STATEMENT OF CASE

APPEAL SITE 26 Netherhall Gardens, London, NW3 5TL

COUNCIL REFERENCE: 2015/3314/P

PLANNING INSPECTORATE REFERENCE: APP/X5210/W/16/3145922

TREES VIEWED FROM THE FIRST FLOOR REAR / SIDE WINDOW TO 24A NETHEHALL GARDENS

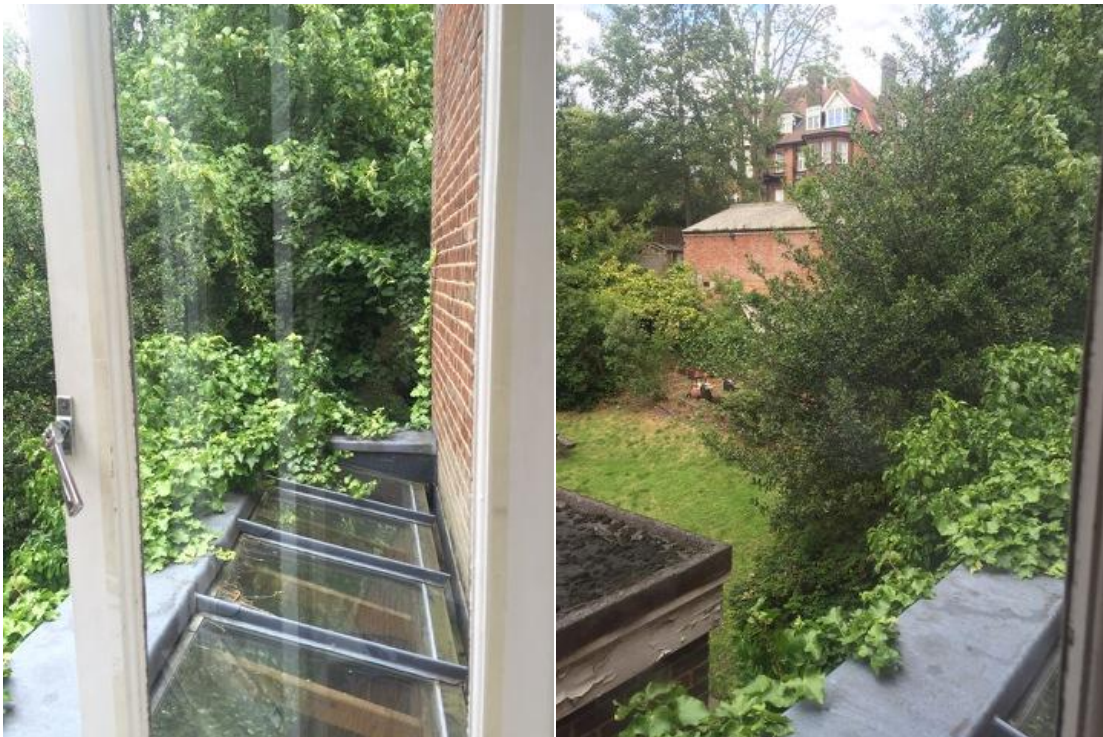
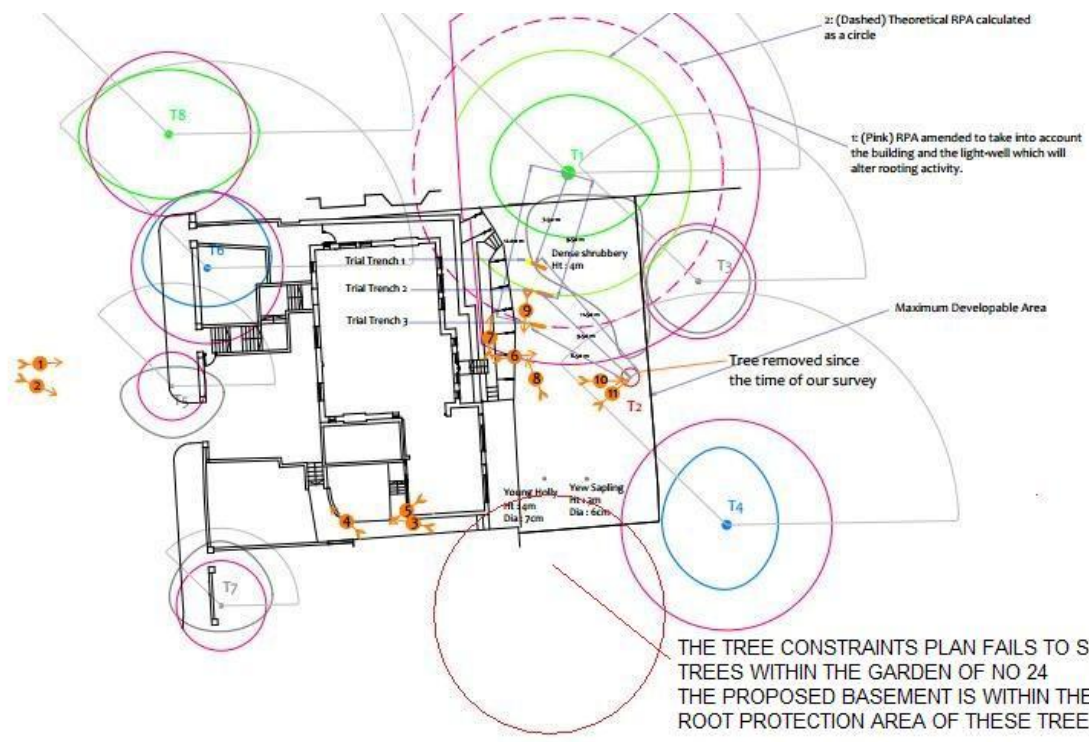
DAMAGE TO TREES

This reason for refusal is still valid as the proposed application fails to take account of trees which are in the garden of No 24A on the boundary

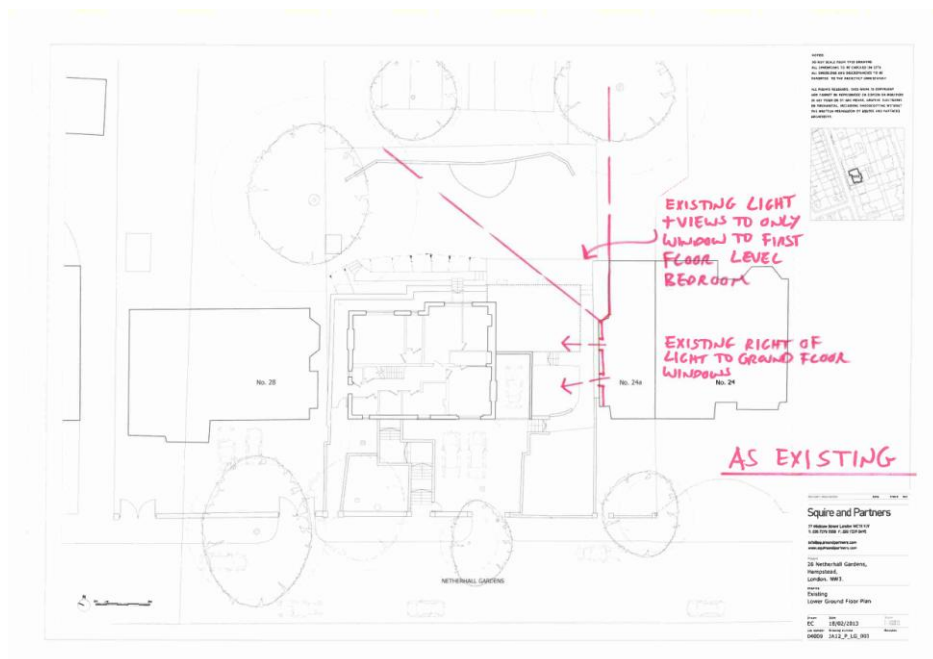
THE TREE CONSTRAINTS PLAN FAILS TO SHOW TREES WITHIN THE GARDEN OF NO 24 THE PROPOSED BASEMENT IS WITHIN THE ROOT PROTECTION AREA OF THESE TREES

LOSS OF LIGHT AND OUTLOOK TO NO 24A NETHERHALL GARDENS

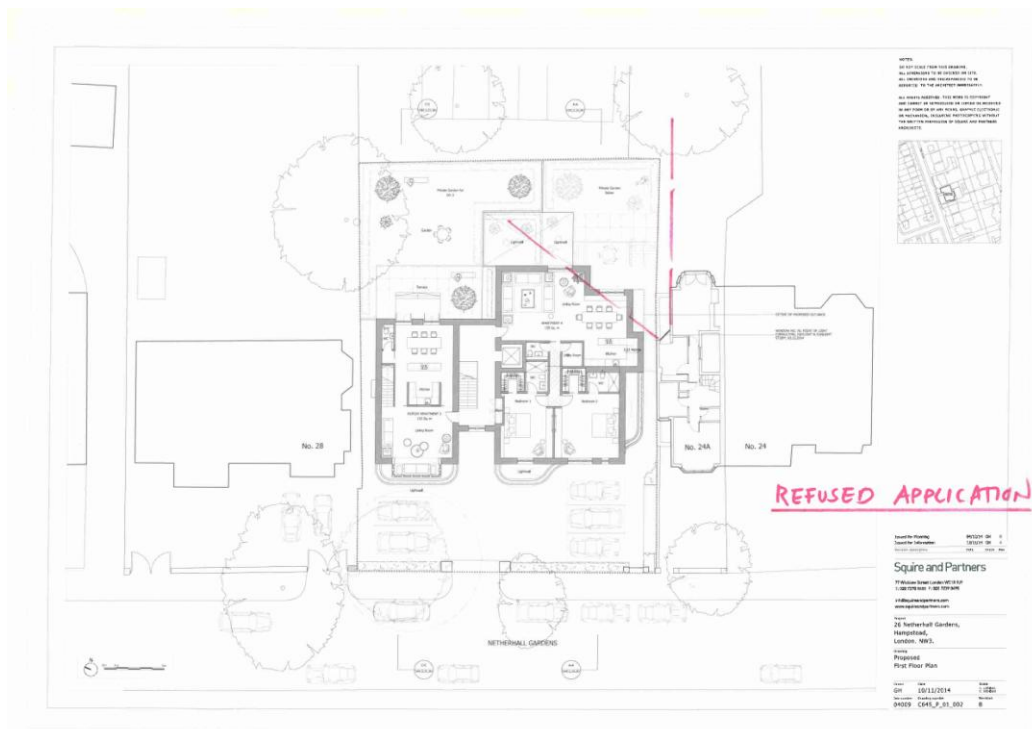
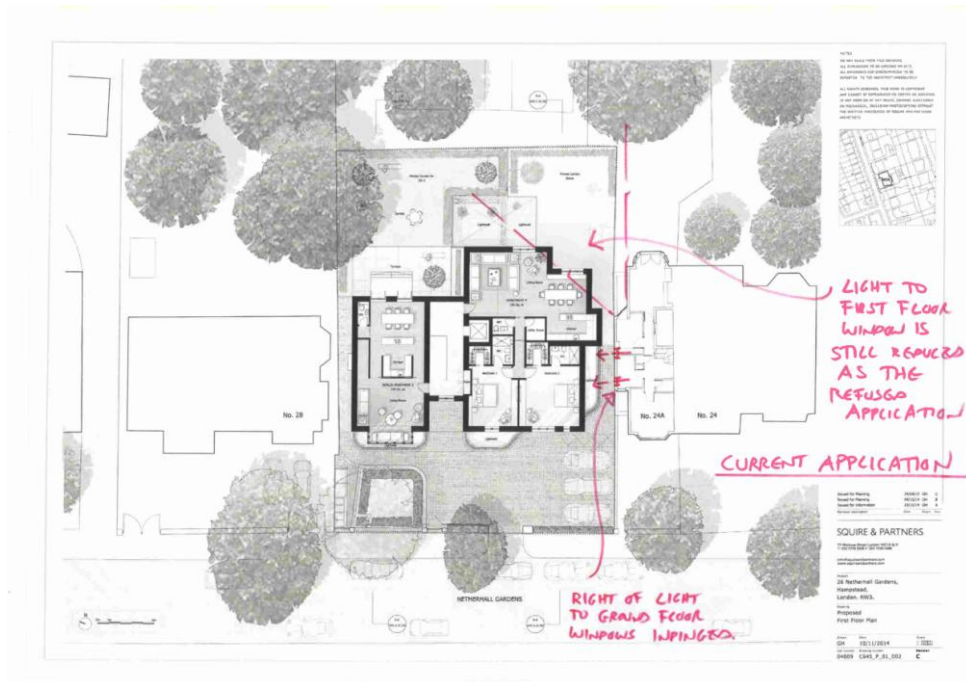
The existing first floor window to the bedroom at No 24A has a window which is at 45deg to the boundary, and currently enjoys light and views as illustrated below.

The relationship between the first floor windows, and the ground floor windows on the boundary has not altered since the previously refused application.
